SERVICE BULLETIN

APPLICABILITY: 2015-2017MY Outback

NUMBER: 12-216-17

SUBJECT: Roof Rail Gapping- Design Change

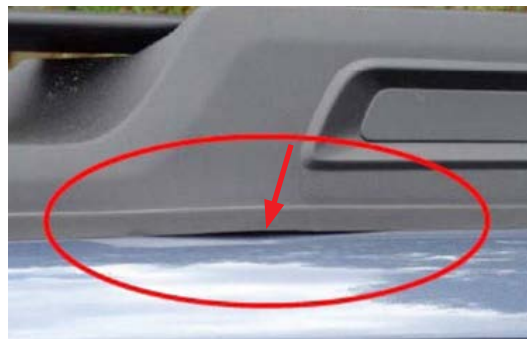
This bulletin announces a design change to the roof rail assemblies. This change has been made in response to isolated customer concerns of a visible gap between the base portion of the rail assembly and the roof panel as shown in the example photo below. The rail's retaining claws have been changed to optimize their holding force and eliminate any gapping.

The new roof rail assemblies were incorporated into production starting with **VIN: H*334404**.

Description	Part Number
ROOF RAIL ASSY RH	91151AL00B
ROOF RAIL ASSY LH	91151AL01B
